Subject: AP1000 COL Standard Technical Report Submittal of APP-GW-GLN-079, (TR 79),
Revision 1

“Electrical System Design Changes”

Technical Report 79

Electrical System Design Changes

Figure 2.6.1-1 (Sheet 1 of 4)
Main ac Power System

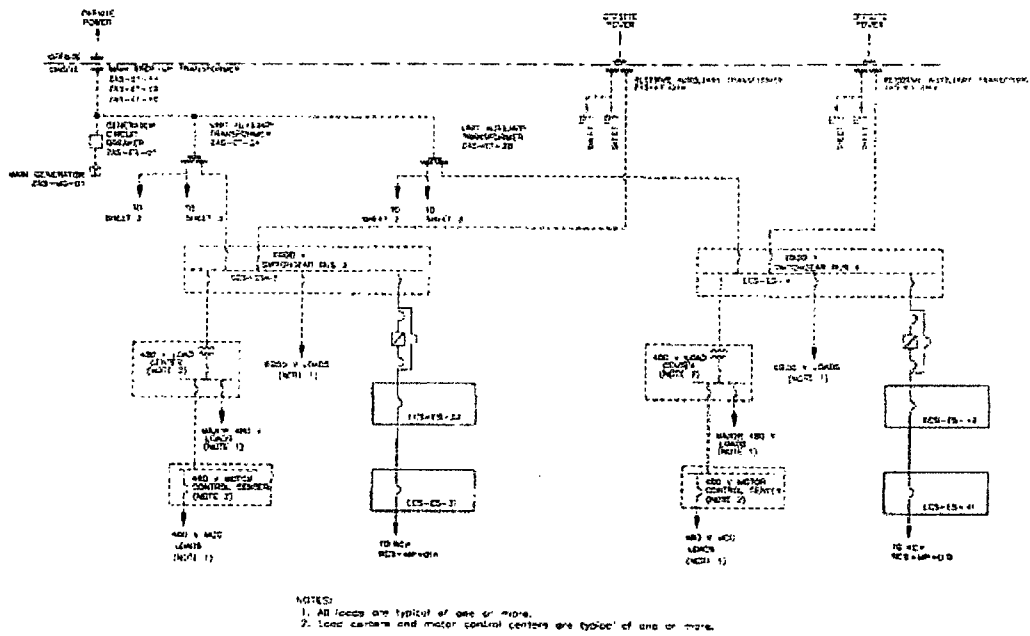
The addition of a fast bus transfer, along with an operator initiated maintenance transfer was made to the AP1000. This change required an additional Reserve Auxiliary Transformer (RAT) to allow complete bus transfer from Unit Auxiliary Transformers to Reserve Auxiliary Transformers. DCD figures 8.3.1-1 and 2.6.1-1 will be revised along with several portions of the DCD text.

The addition of a fast bus transfer, along with an operator initiated maintenance transfer was added to the AP1000. This change required an additional Reserve Auxiliary Transformer (RAT) to allow complete bus transfer from Unit Auxiliary Transformers to Reserve Auxiliary Transformers.

Figure 2.6.1-1 (Sheet 3 of 4)
Main ac Power System

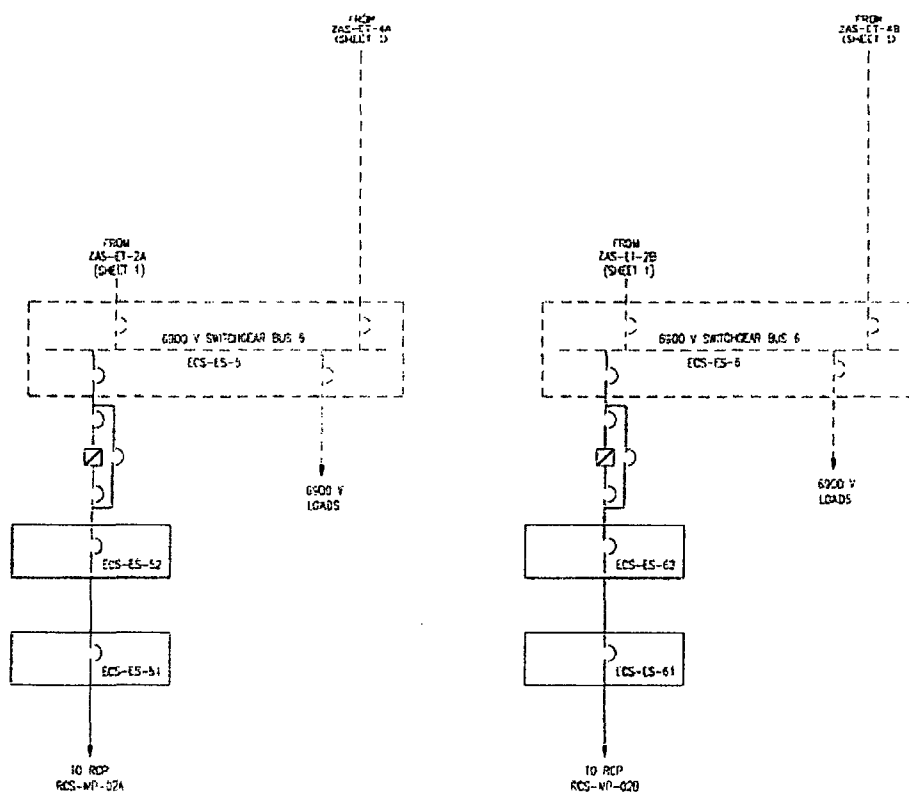
Item: Input and output isolation breakers to each RCP variable frequency drive unit were added (pages 8.3-53, 2.6.1-11, and 2.6.1-13).

Figure 3.8.2-4 (Sheet 6 of 6)
Containment Penetrations
Typical Electrical Penetration

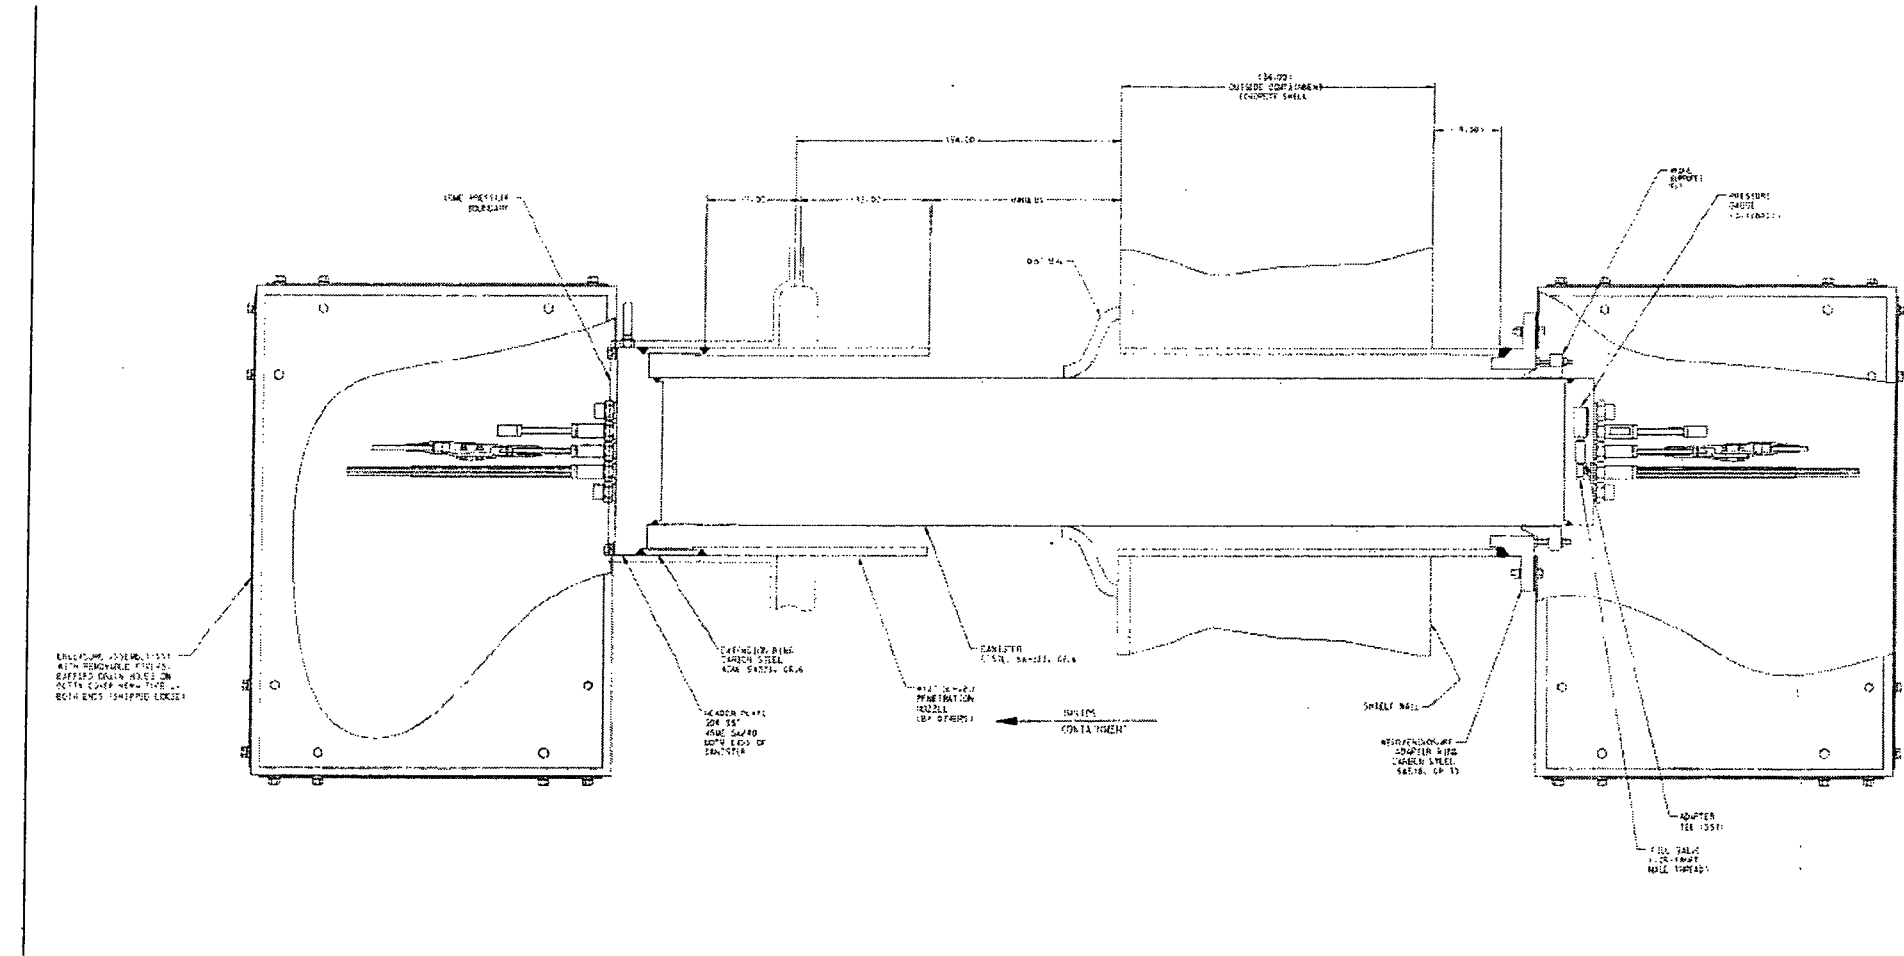
Additionally, when the Containment Vessel is pressurized, the current configuration of the electrical penetration may not be able to accommodate the radial displacement of the Containment Vessel shell due to the electrical penetration being welded to the fixed enclosure. A change from a welded connection to a supporting edge with a tapered leading edge and threaded rod to permit concentric alignment of the Electrical Penetration Assembly canister in the nozzle is recommended by a penetration manufacturer.

Figure 3.8.2-4 in the DCD was based on the epoxy construction type of electrical penetration. This DCD figure was revised to allow both types of electrical penetrations. Additionally text changes within the DCD were made to allow for penetration types other than epoxy construction type.

Figure 8.3.1-3

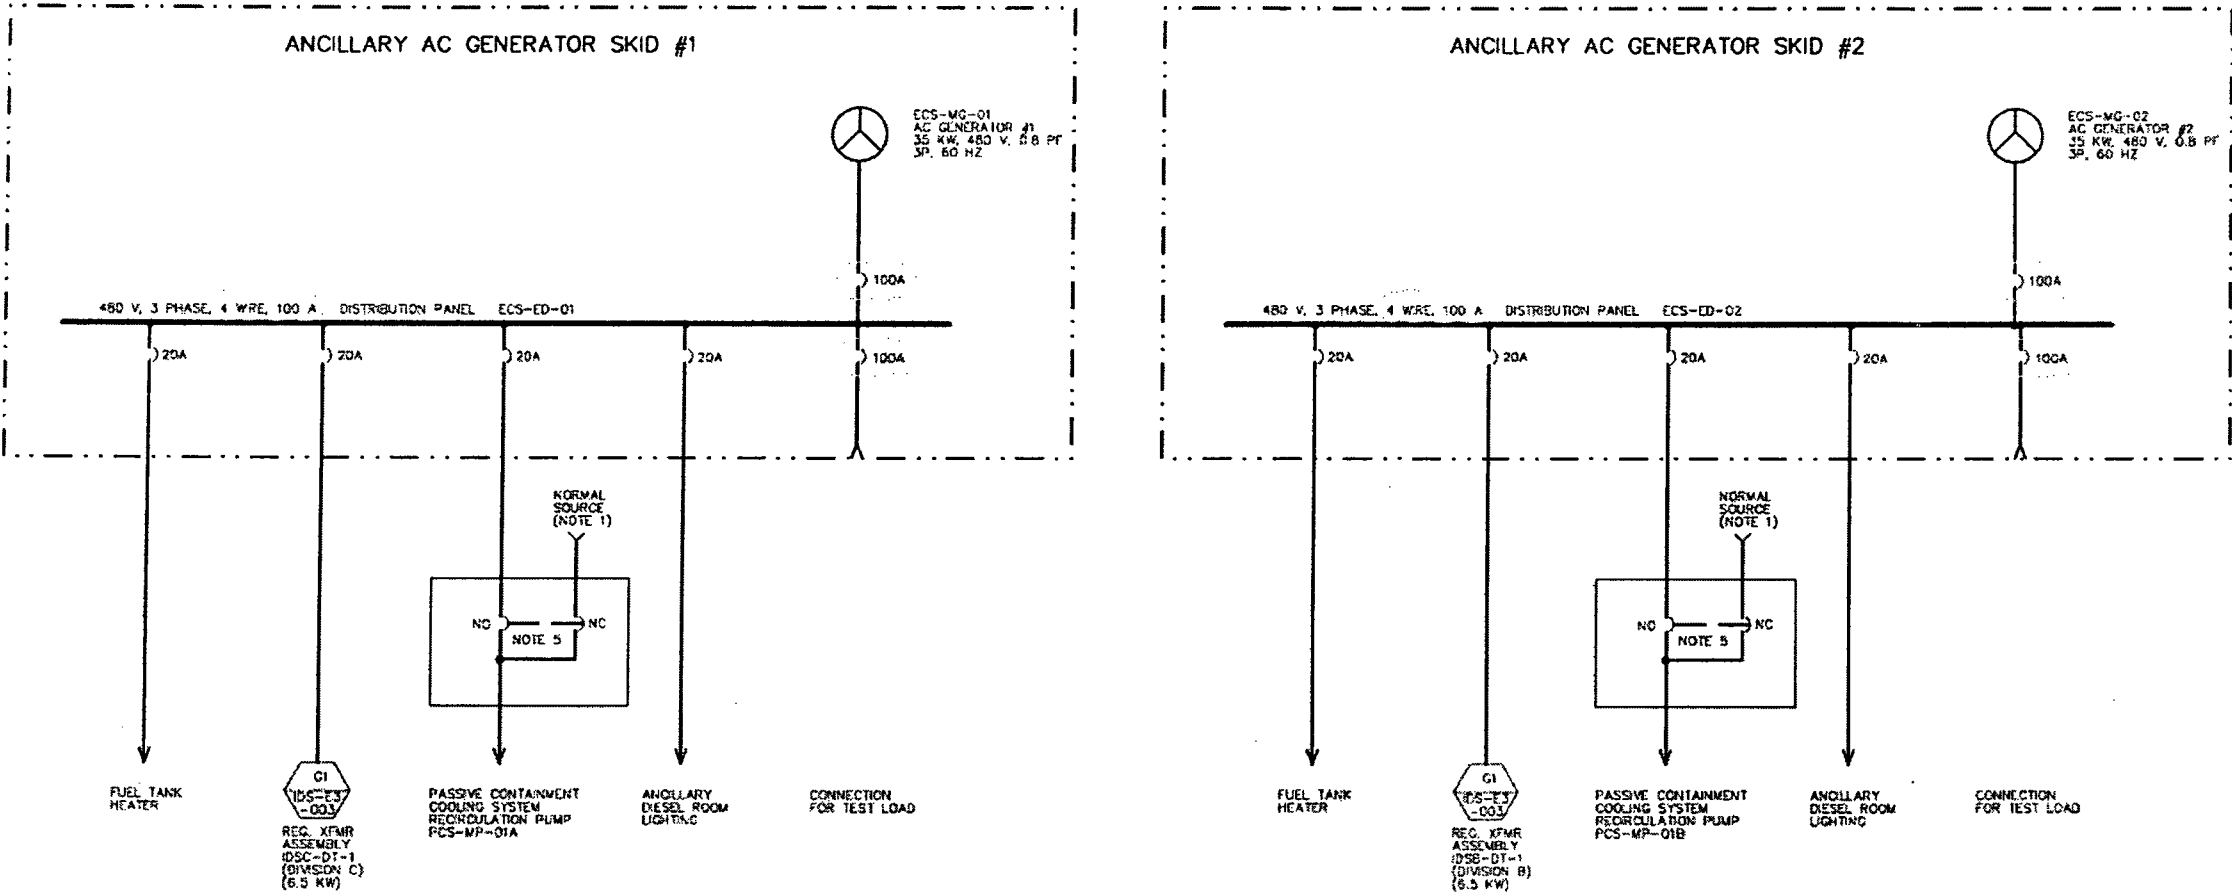
Item: Ancillary diesel 1-line Figure 8.3.1-3 was revised to reflect a 4 wire 100A distribution panel (from a 3-wire 50A), and a 100A breaker for both the diesel generator to the bus and for the test load tie to the bus from 50A (page 8.3-56).

The size of the ancillary diesel generator distribution panels are shown as 50A with an incoming breaker of 30A from the generator. Full load current of this generator is approximately 53A. The main breaker of the distribution panel should be sized at the full capacity of the generator at a minimum. The diesel generator test load will also be changed to 100A to allow for this generator to be tested at full capacity. Additionally, to facilitate the use of this source as a feed to 277Vac lighting circuits, these panels will be changed from 3W to 4W.

A review of industry standard product offering for 480Vac distribution panels shows that the minimum sized standard product is a 100A main breaker, 100A main bus. The rating of these panels will be changed to reflect this 100A rating based on the ready availability of standard product offerings.

Item: Ancillary diesel 1-line Figure 8.3.1-3 was revised to reflect a 4 wire 100A distribution panel (from a 3-wire SOA), and a 100A breaker for both the diesel generator to the bus and for the test load tie to the bus from SO (page 2.3-56).

Figure 8.3.1-3 of Revision 15 was revised to reflect a 4 wire 100A distribution panel, and a 100A breaker for both the diesel generator to the bus and for the test load tie to the bus.
